FIVE ESTUARIES OFFSHORE WIND FARM

10.56 APPLICANT'S RESPONSES TO THE
REPORT ON THE IMPLICATIONS FOR
EUROPEAN SITES (RIES)

Application Reference:	EN010115
Document Number:	10.56
Revision:	A
Pursuant to:	Deadline 7
Eco-Doc Number:	005711023-01
Date:	March 2025

APPENDIX 1: PHOTOGRAPH OF ORFORD NESS, 1972

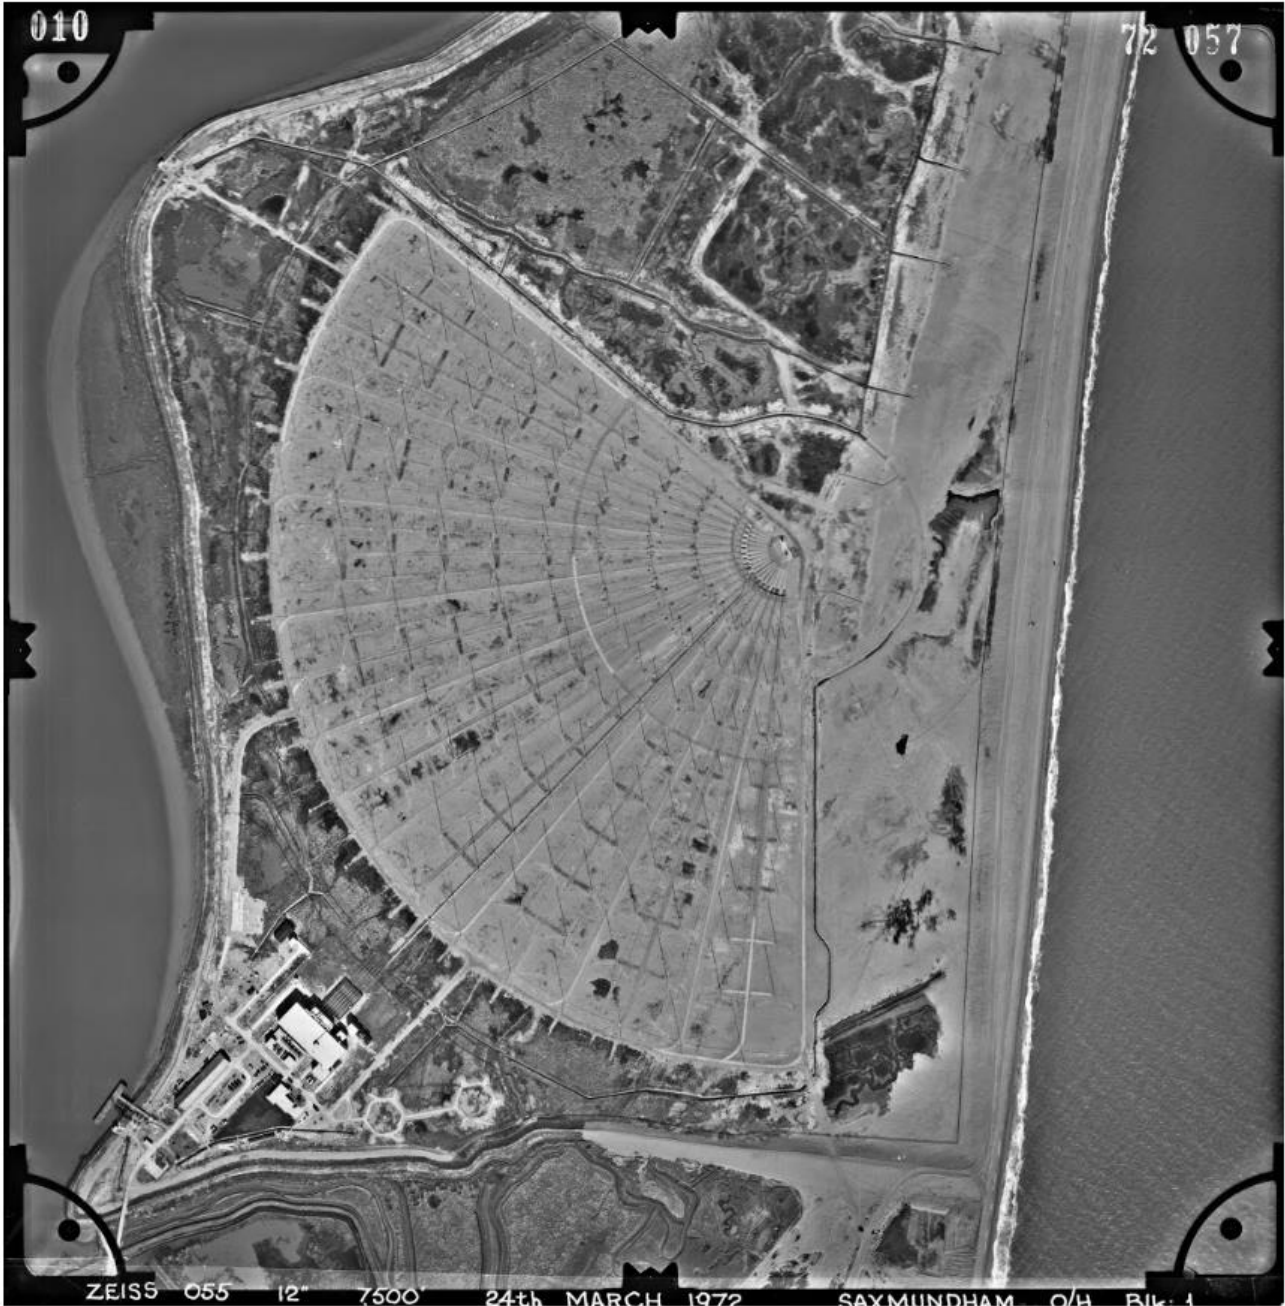
QT2.1.5	NE		Confirm if these matters are resolved. If not, confirm for which European sites and qualifying features you are not content and identify what further assessment you consider is required from the Applicant.	This question is not directed at the Applicant.
QT2.1.6	Applicant	<p>Unexploded ordinance</p> <p>National Trust [RR-080] raised the risk that the proposed LBBG compensation site has the potential for unexploded ordinance (UXO) present. This is not considered as an impact pathway in the LBBG HRA.</p>	What risk is posed to the designated sites from the potential presence of UXO at the LBBG compensation site? Address this in the LBBG HRA if required.	As set out in the LBBG Site Selection and Roadmap [ref] in Table 4.1 the National Trust advised the Applicant to avoid proposed site AOE VE03 (located south of the existing Norfolk and East Anglia compensation site) due to potential UXO. The AOE VE03 site has been largely unaffected by human activity and therefore may have a higher potential for UXO. The chosen site on Cobra Mist has been subject to significant intervention and modification with vehicle tracks from the 1970s still visible in aerial photography (as described in response NE40 [REP5-

Ref	Question to:	Issue and detail	Question	Applicant's response
				074]). Please see Appendix 1 for an aerial photograph. It is therefore considered that the site has already experienced disturbance far greater than the associated with the proposed works and the risk of finding UXO is no different to any other piece of land. In this context, where identifying UXO would be an exception, it is not considered as a specific pathway.
Q3.1.3	Applicant	<p>The conservation objectives for the European sites for which an LSE was identified by the Applicant at the point of the Application's submission were included within the Summary of Designated Sites [APP-044] for the Proposed Development and in the LBBG HRA Report [APP-045] (Table 3.1) for the LBBG compensation works.</p> <p>The Summary of Designated Sites [APP-044] states for Foulness (Mid Essex Coast Phase 5) Ramsar (paragraph 7.1.3) and Humber Estuary Ramsar (paragraph 30.1.5) that conservation advice packages are not produced, therefore the Applicant has applied the conservation advice for overlapping European designations where qualifying features align. Within [APP-044] the following Ramsar sites do not have identified conservation objectives and there is no reference as to whether the conservation advice packages from overlapping designations have been applied (though all have SPA overlapping designations):</p> <ul style="list-style-type: none"> > AOE Ramsar site > Abberton Reservoir Ramsar site > Blackwater Estuary (Mid-Essex Coast Phase 4) Ramsar site > Deben Estuary Ramsar site > Colne Estuary (Mid-Essex Coast Phase 2) Ramsar site > Hamford Water Ramsar site > Dengie Estuary Ramsar site > Minsmere-Walberswick Ramsar > Stour And Orwell Estuaries Ramsar site 	Confirm if in the absence of conservation advice packages for the Ramsar sites listed above, whether conservation objectives from overlapping designations have been applied. Update the Summary of Designated Sites [APP-044] to clarify this.	The Applicant has updated 5.4.4 Summary of Designated Sites – Revision B for Deadline 7.
